CLOVERLEAF FILING NO. 2

A REPLAT OF A PORTION OF TRACT B, WOODMOOR PLACER

JOB NO. 25158.01
MAY 7, 2021
SHEET 1 OF 7

JOB NO. 25158.01
MAY 7, 2021
SHEET 5 OF 7

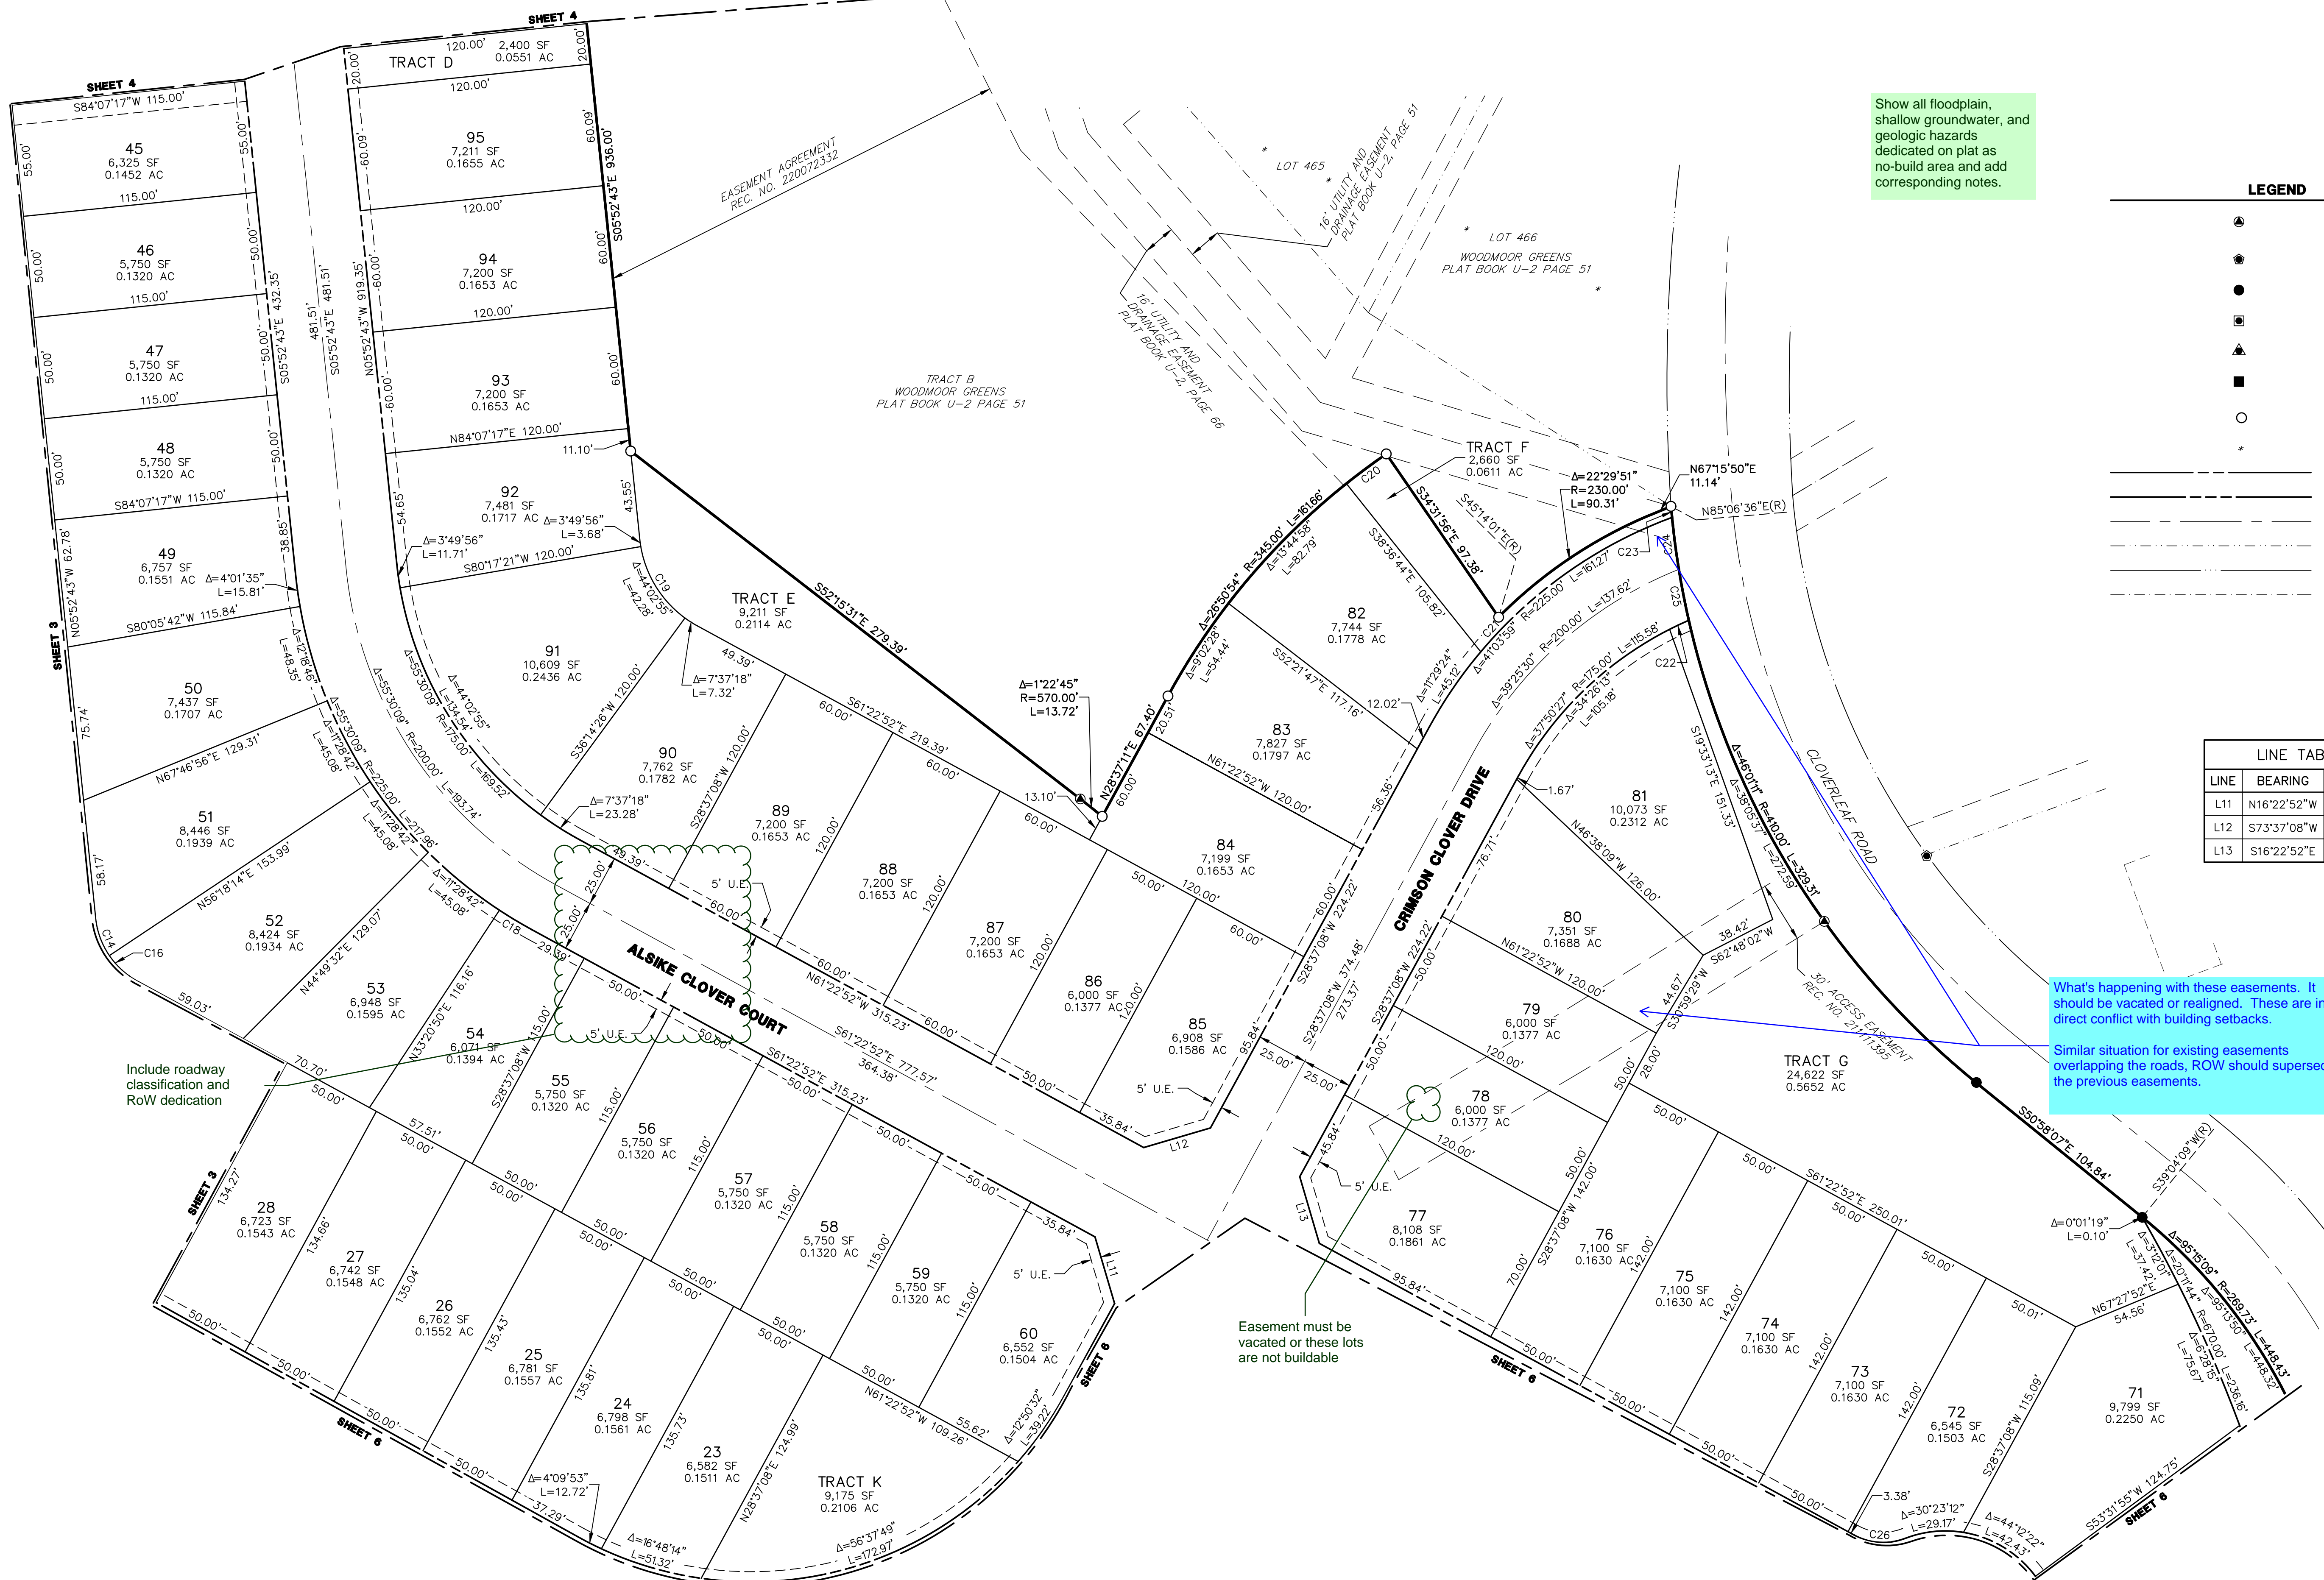
Show all floodplain, shallow groundwater, and geologic hazards dedicated on plat as no-build area and add corresponding notes.

Change the matchline linetype so it's not confused with the road centerline. typical on all sheets

A retaining wall is constructed within lots 67, 68, 127-132. Add a plat note specifying who will own and maintain the retaining wall. If the district then include an easement.

Add the sight distance easement shown on the preliminary plan

Add all abbreviations to the legend or revise the callouts.

Revise tract J to be consistent with the preliminary plan which included Walter's Point

what is this line?

JOB NO. 25158.01
MAY 7, 2021
SHEET 7 OF 7

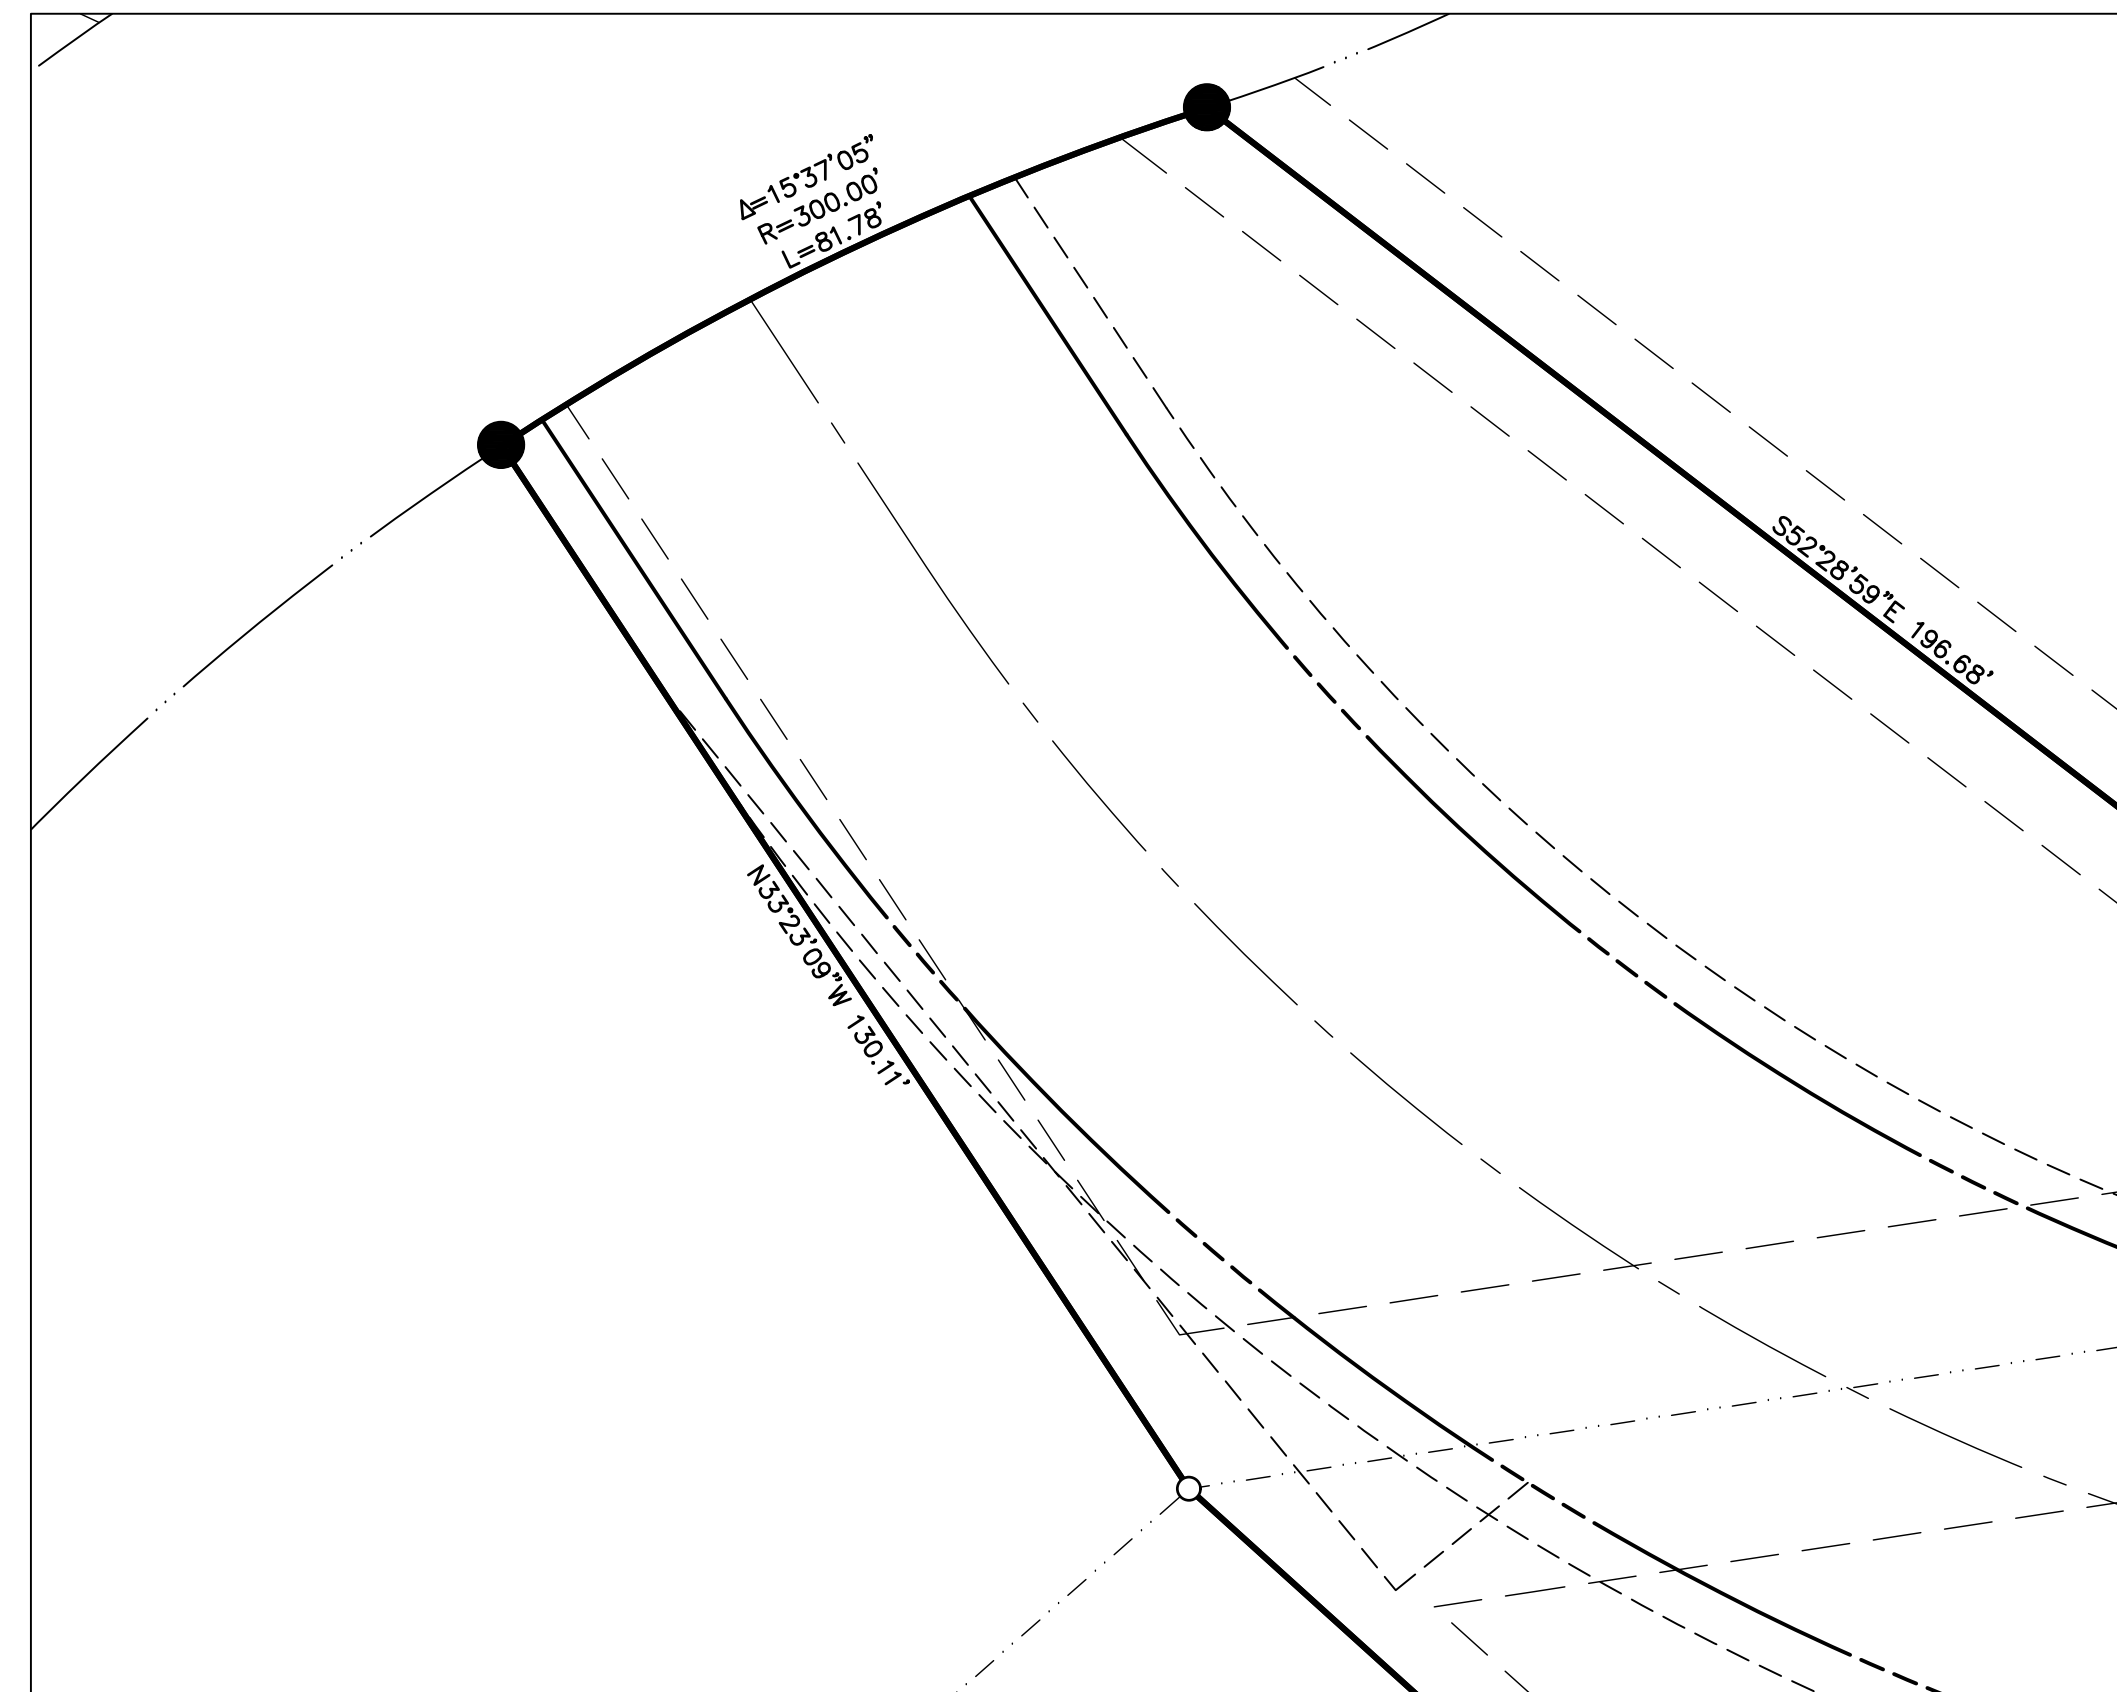
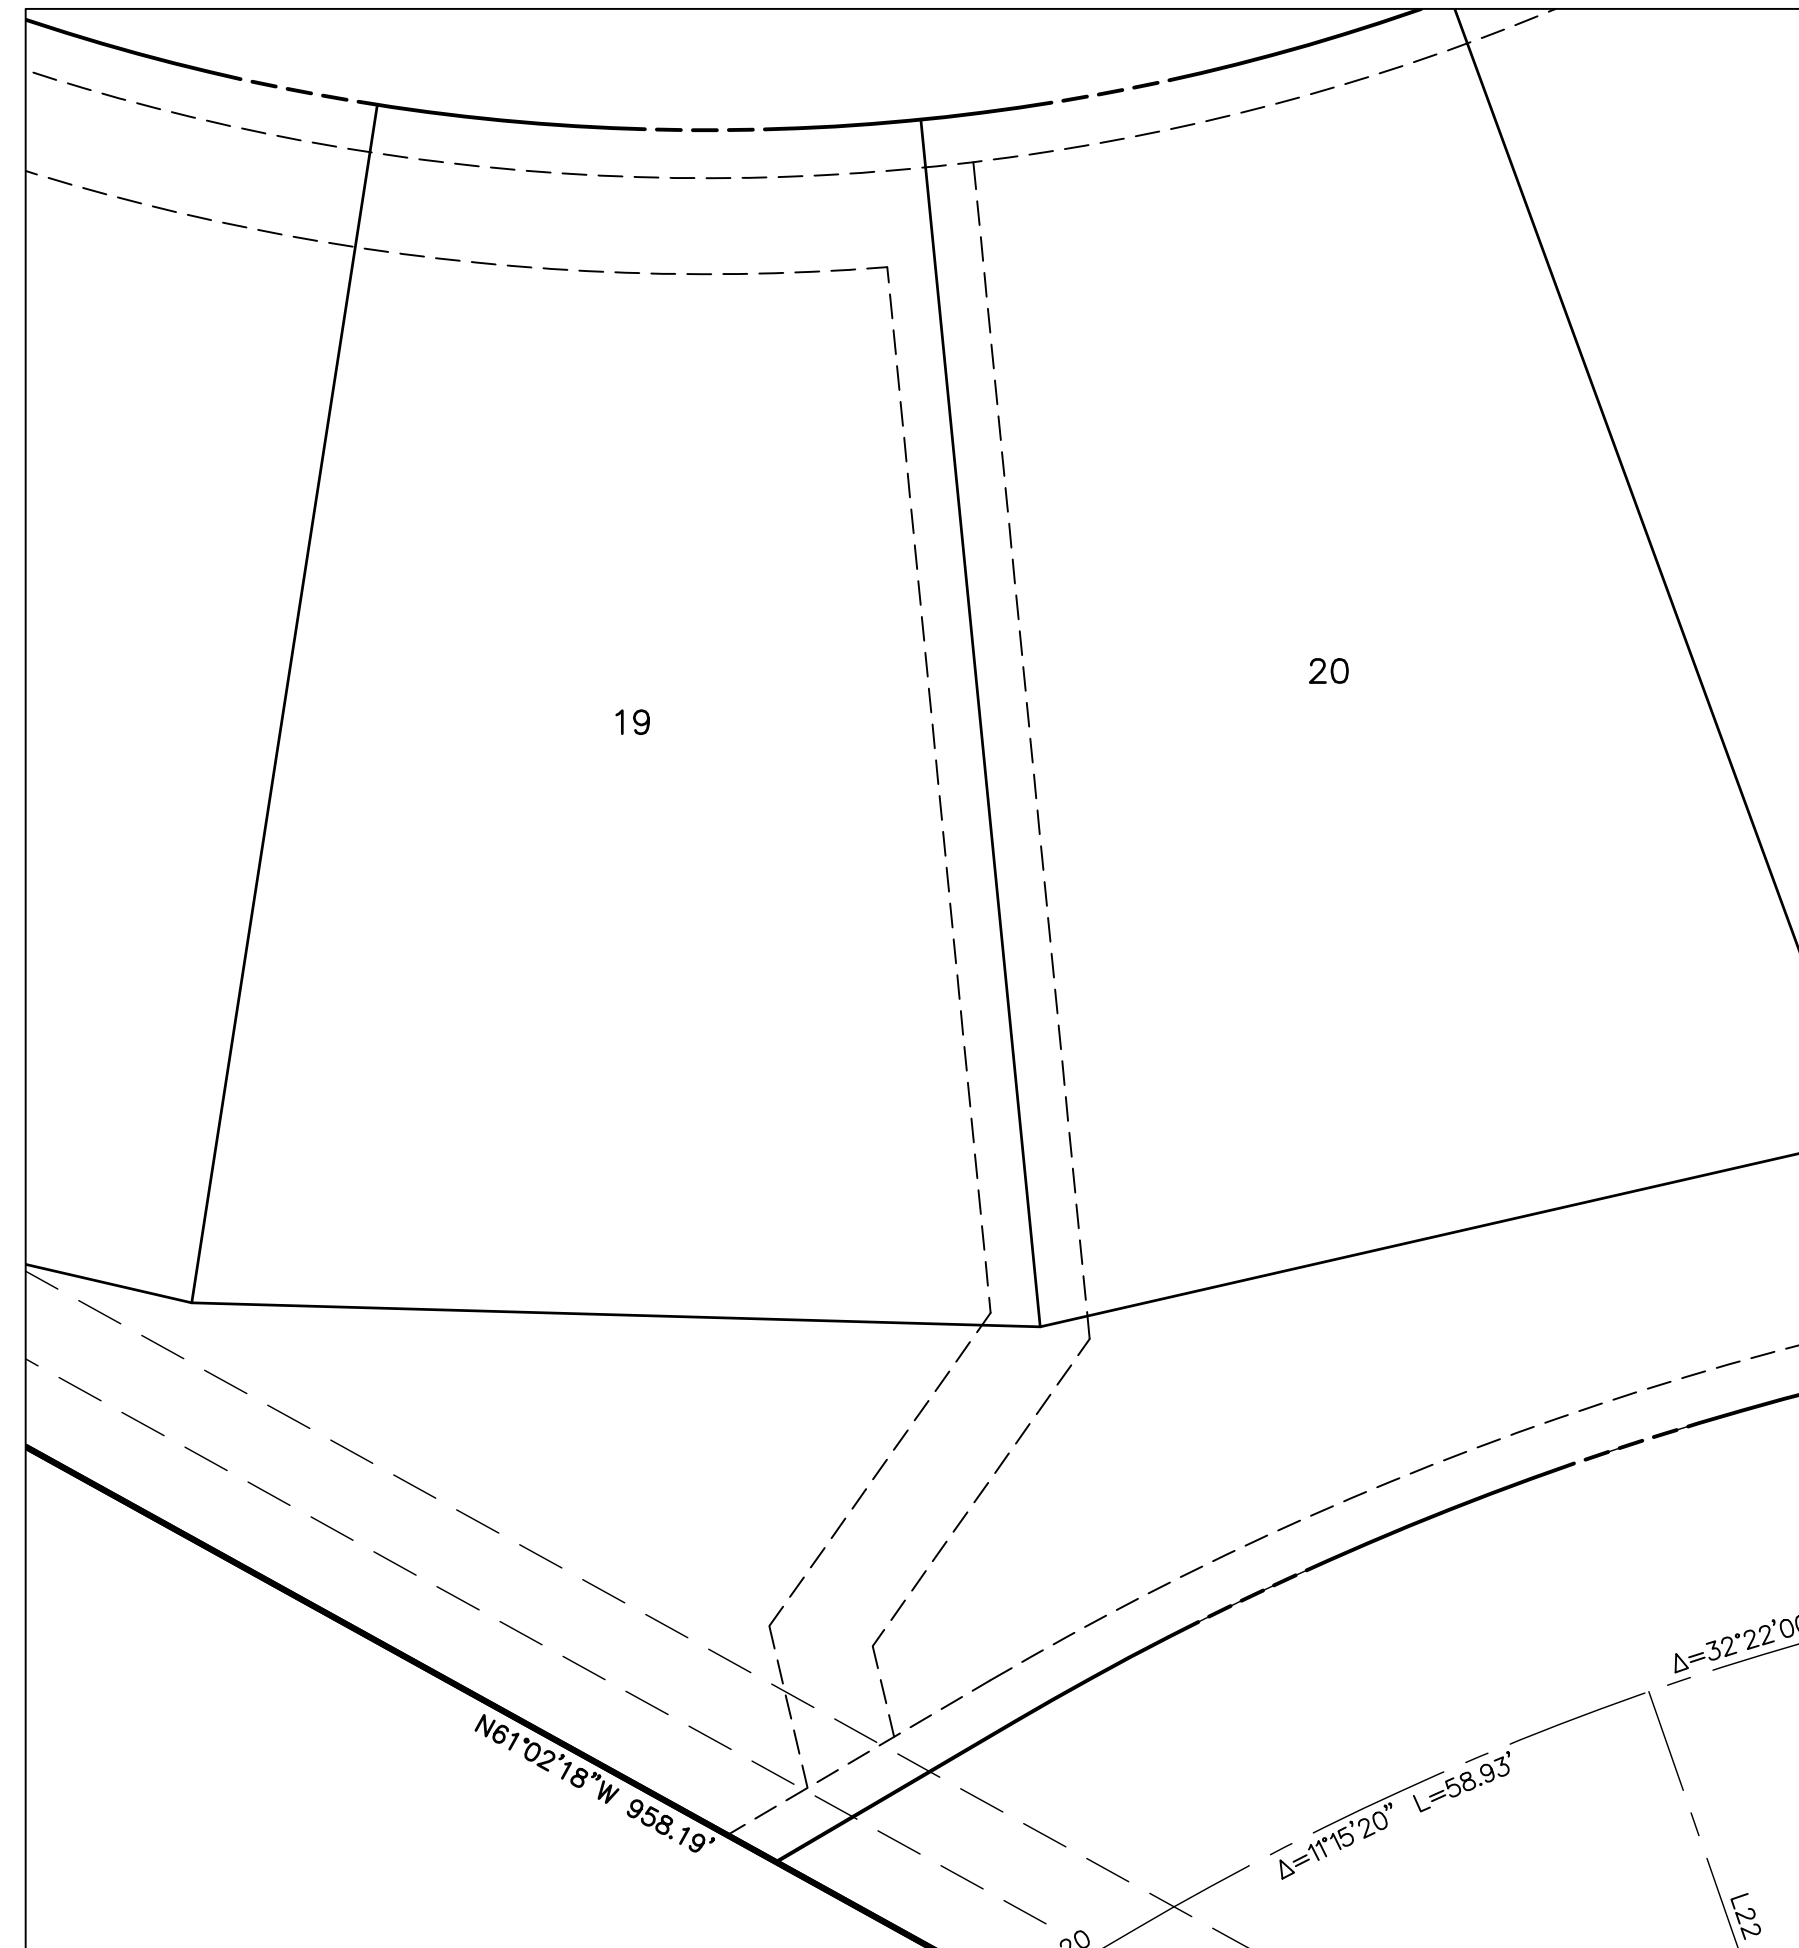
Increase text size so it's legible

Not sure what the specific information this page is trying to convey.
If it's the easements then provide the bearing/distance information for the easements
Will be reviewed on the resubmittal
